Application for a site compatibility certificate - SCC_2019_TWEED_001_00

With reference to your letter dated 23/7/2019 seeking comment on the site compatibility certificate for Nos. Lot 18 DP 627632 No. 27 and Lot 22 DP 1170438 No. 49 Elouera Terrace, Bray Park the following is provided:

Figure 1

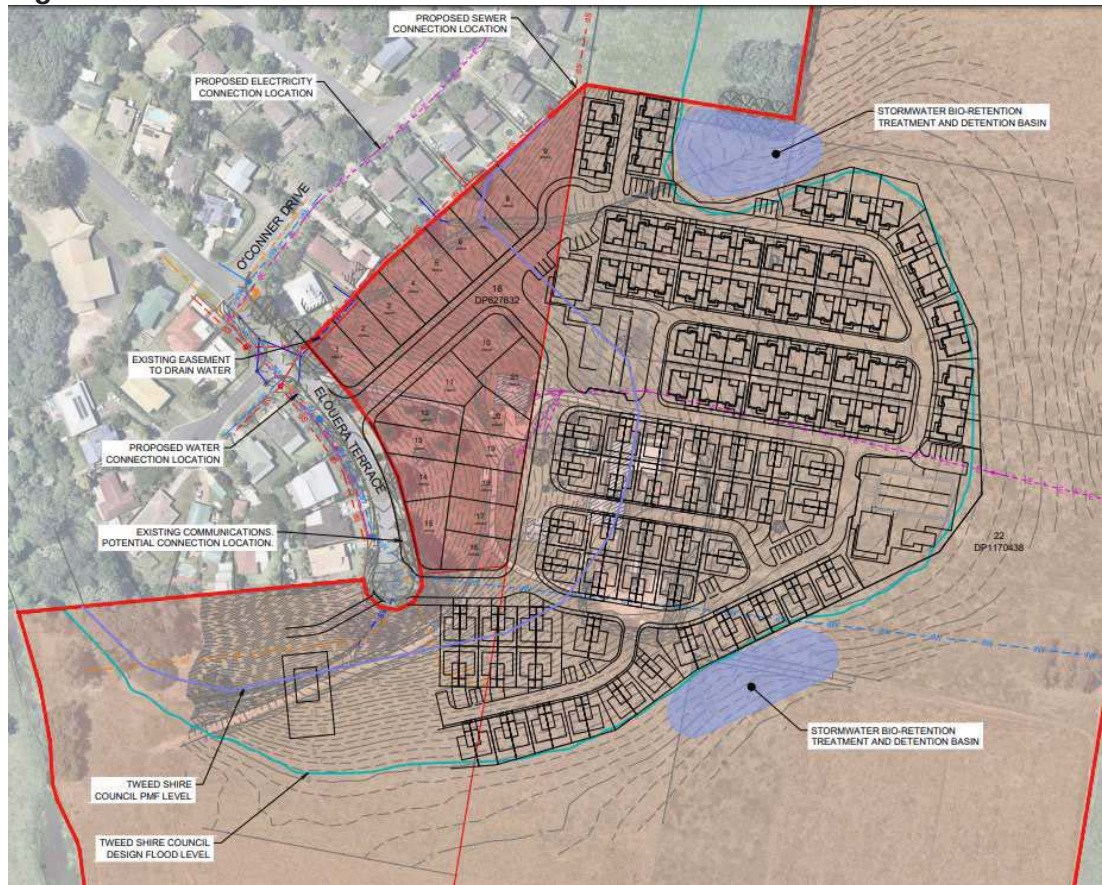
- a) The site plans (see Figure 1 below) show future residential subdivision on the R2 zoned portion of the land. This area is also the majority of the flood free land on the site, being above the PMF. A more appropriate process would be for the applicant to reconfigure their development proposal, to centralise the more sensitive, higher density land use (being aged housing) on the flood free portion, and then seek a planning proposal for the remaining land above the 1% AEP for other residential uses. Instead, the site design has been driven by the zoning boundaries and the use of the Seniors Housing SEPP in the RU1 zone, without due consideration of flood risk. Please note these comments are not to be taken to assume any endorsement of a planning proposal.

Figure 21 – Site Opportunities and SCC Footprint

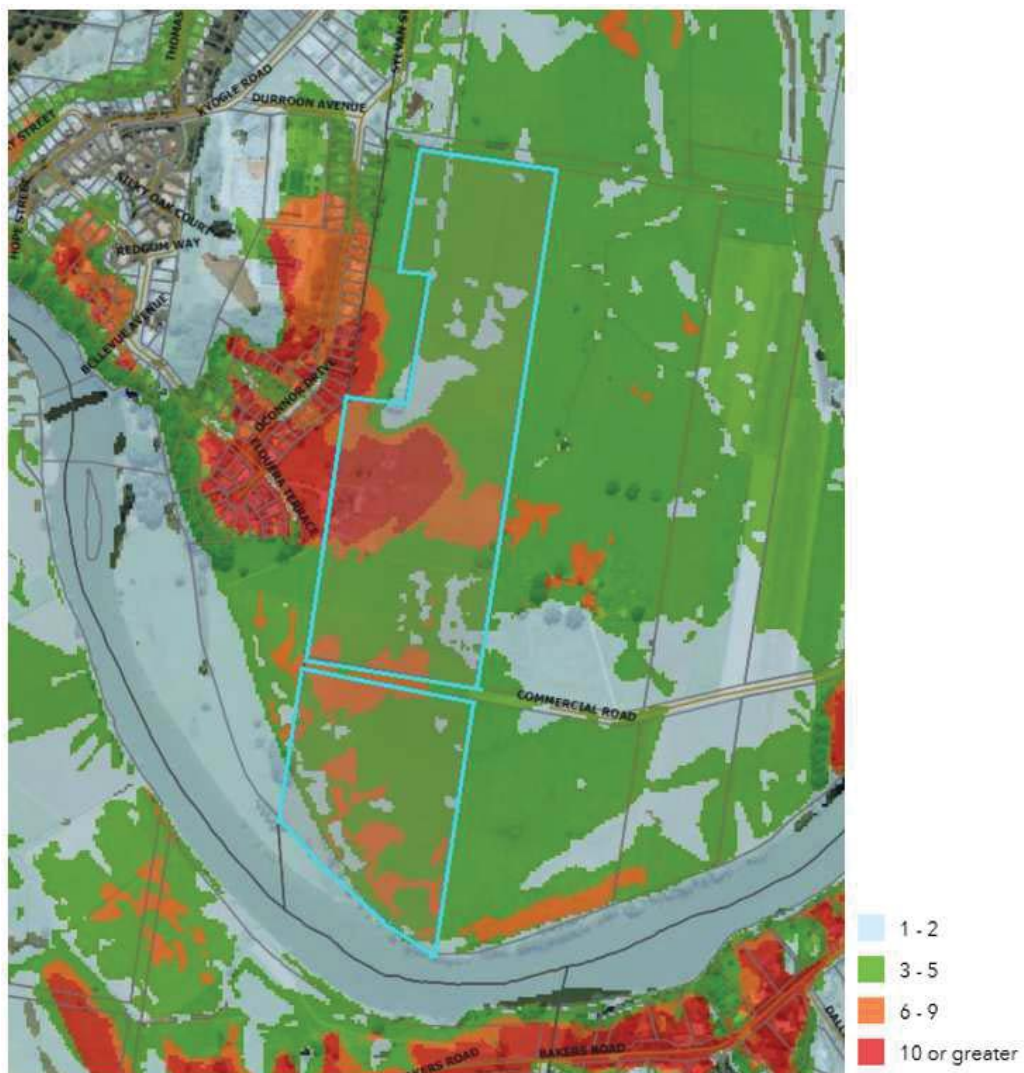
The indicative development footprint is presented in the application documents as Figure 21, shown below. This footprint correlates almost exactly with the most visible portion of the site as mapped by the Scenic Landscape Strategy Visibility Map (Figure 2).

Indicative footprint and extent of visual change to the landscape as viewed from the Margaret Olley Tweed Regional Art Gallery

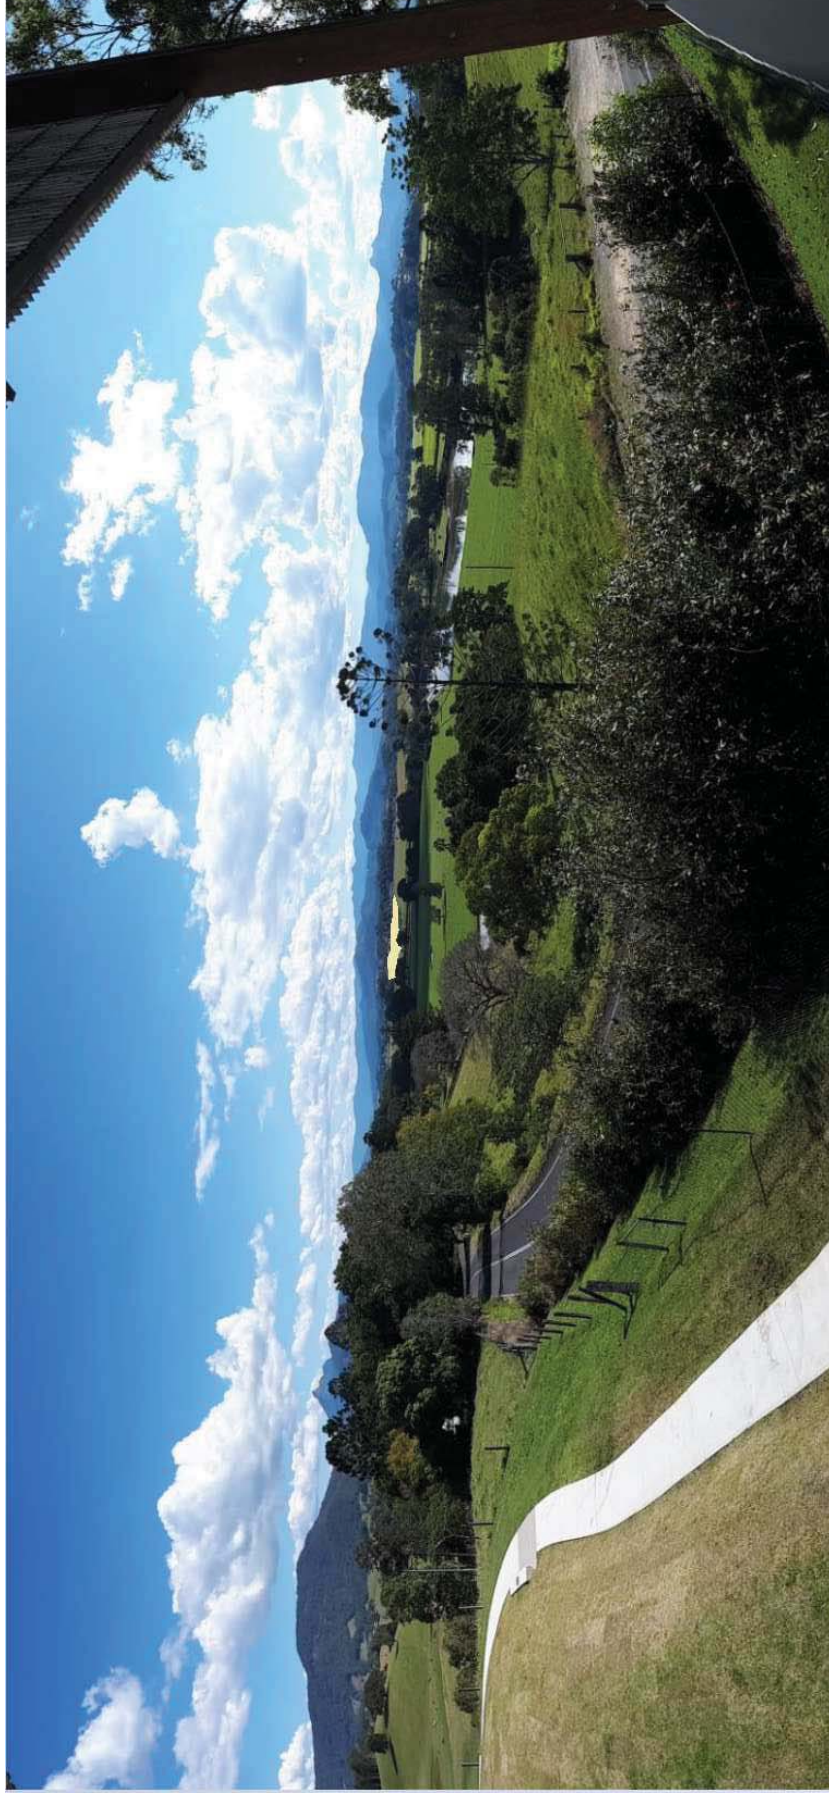
Indicative photo montages are provided following showing the likely extent of the proposal footprint into the landscape as viewed from the gallery observation deck and café.

The expected visual intrusion into the foreground of the view as experienced from Bakers Road and Amarillo Drive intersection is shown on the images below. This location is a suitable stopping place for tourists to pull over to enjoy the view, which would be significantly altered by the proposal. Again, this view provides a similar landscape setting to the view experienced from the Art Gallery, which encompasses a primarily natural setting and many iconic landscape characteristics of the Tweed such as sugar cane, the Tweed River and the forested hills of the volcanic shield the caldera.

Development of the residential zoned land in and of itself will result in significant alteration of the visual environment, and the cumulative impact of development of the additional land as sought by the SCC is considered to be unacceptable due to its incompatibility with the iconic, high quality view experienced from the Tweed Regional Art Gallery and Bakers Road, as well as 12 other priority viewing situations identified under the draft Tweed Scenic Landscape Strategy through extensive community consultation.
